STAFF RECOMMENDATION

**403 Chapel Avenue
September 18, 2013**

Application: New construction - infill
District: Eastwood Neighborhood Conservation Zoning Overlay
Council District: 06
Map and Parcel Number: 08302011200
Applicant: Ron Burkett, Builder
Project Lead: Sean Alexander, sean.alexander@nashville.gov

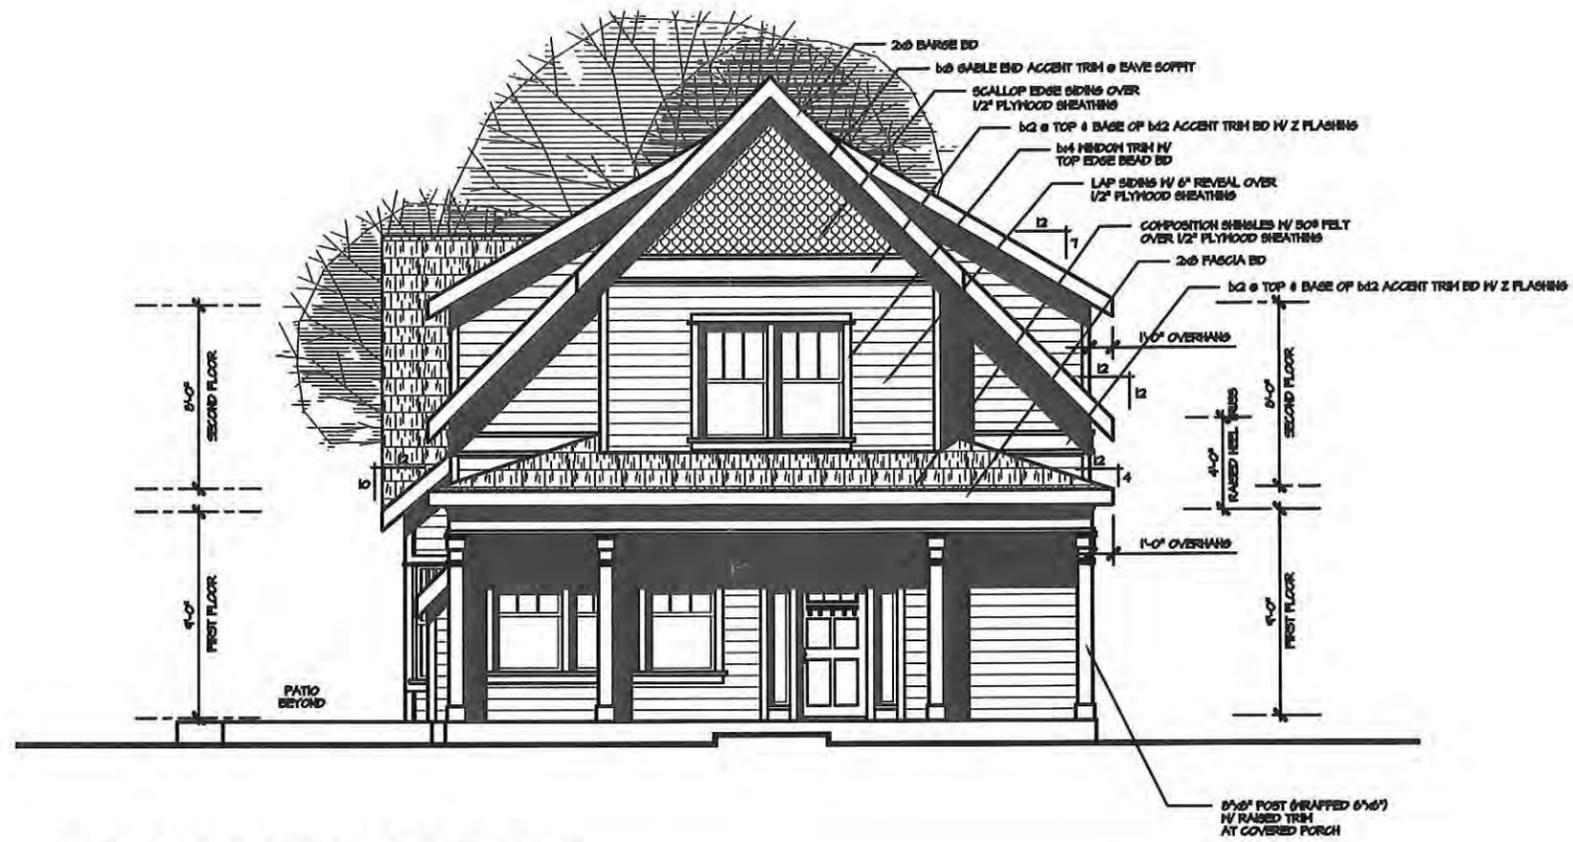
The slope of the lot appears to slope down to the rear, which is not properly depicted in the submitted drawings. This would have the effect of lowering the actual height of the building, which may reduce the perceived scale. Corrected drawings will need to be submitted before a permit is issued.

The submitted plans do not show paving for parking or sidewalks. A front sidewalk should be added to be compatible with the historic houses.

FRONT ELEVATION

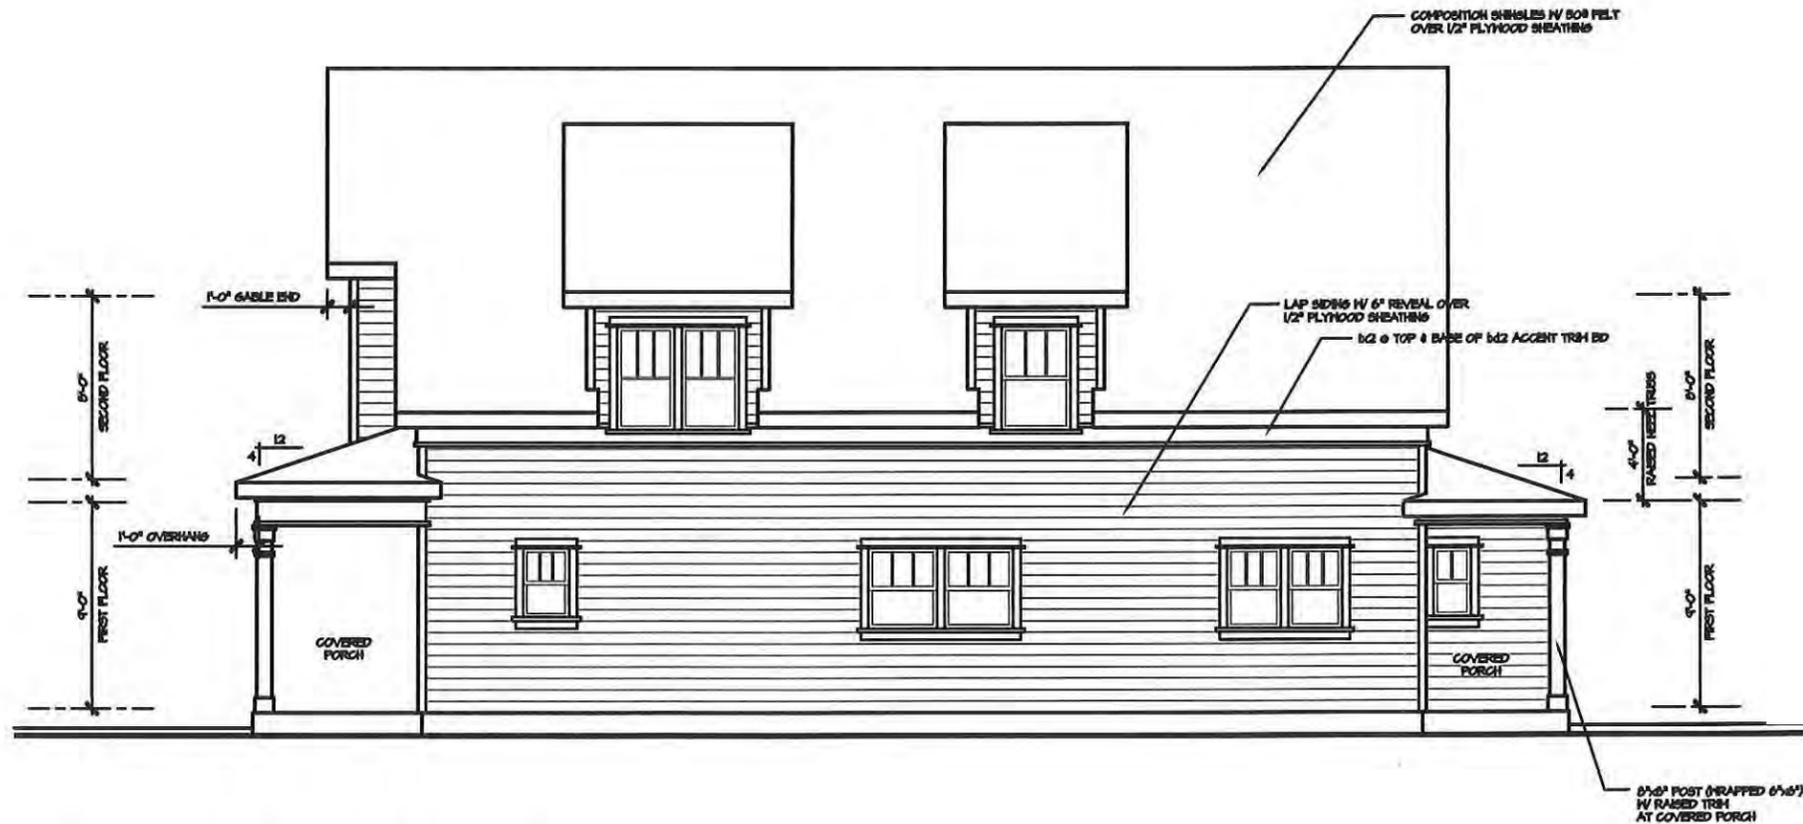
The upperstory will have a three-foot (3') knee-wall, with the ceiling expanded by a projecting bay in the front gable field, extending three feet (3') forward of the primary wall over the front porch and shed-roofed wall dormers on each side. Projecting upperstory bays and wall dormers are not typical features in the historic district. Setting the dormers back from the side walls and the front bay flush with the primary front gable would be more compatible with existing forms. With those modifications, staff finds that the new building would meet guidelines II.B.1.a and II.B.1.b.

The location and rhythm of windows on the front and side elevations will be compatible with surrounding historic houses. The proportion of windows is would not be compatible with historic context because the first-story windows would be square and would be shorter than the windows in the upperstory. Typically windows on the first story of a house are vertically oriented (taller than they are wide), and are taller than the windows of the upperstory or the same size. With the first-story windows enlarged to be a more appropriate proportion, staff finds that the new building would meet guideline II.B.1.g.

1. All exterior materials, paving, and utility locations be approved by staff;
2. That the front bay not project from the primary wall and that the side gables be set in two feet (2') from the walls below;
3. That the window sizes be revised so that the first-story windows are appropriate and in proper proportion to the upperstory windows; and
4. That final drawings showing all changes be submitted before a permit is issued.
